COMPUTIME LTD.				
DRAWN:ZJ SONG	DATE: Sep 12.05	SUN005A10A(BASE)		
CHK:	DATE:	APP:	DATE:	REV:02
RELEASE:	DATE:	SCALE: NONE	LOGIC PART	SHEET: 1 OF 4

COMPUTIME LTD.				
DRAWN:zj song	DATE:Feb 10,06	SUN005A10A(BASE RF-RX)		
CHK:	DATE:			
APP:	DATE:	A3	RF PART	REV:03
RELEASE:	DATE:	SCALE:NONE	SHEET:2 OF 4

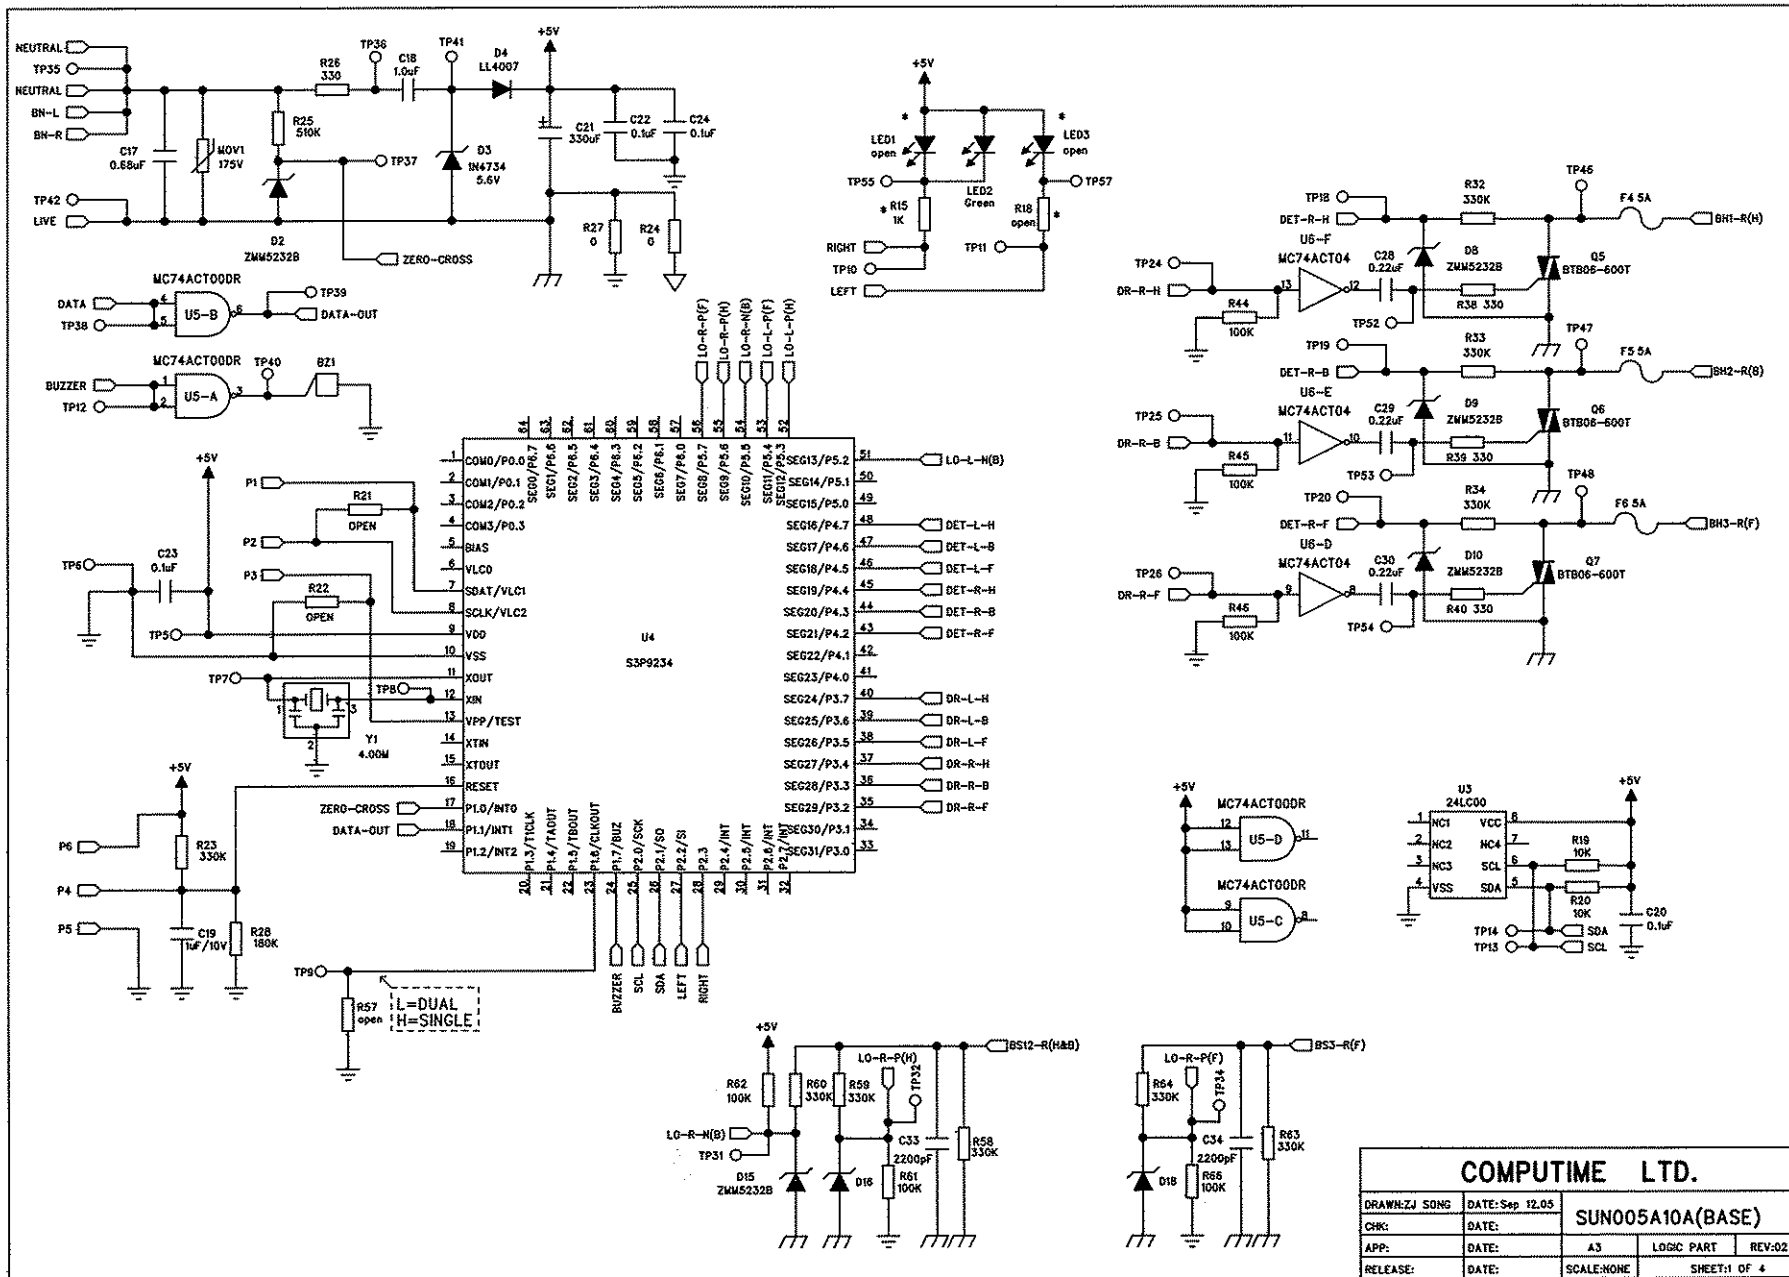
REV	CHANGE DESCRIPTION	APPROVED	DATE
01	Original		Dec 29,04
02	Change C7 and C9 from 1uF to 0.1uF		Sep 12,2005
03	Change R3 from 5.6K to 8.2K		
04	1.Change C6 From 5pF to 6pF 2.Change C17 From 0.15uF to 0.68uF		Mar.27.06
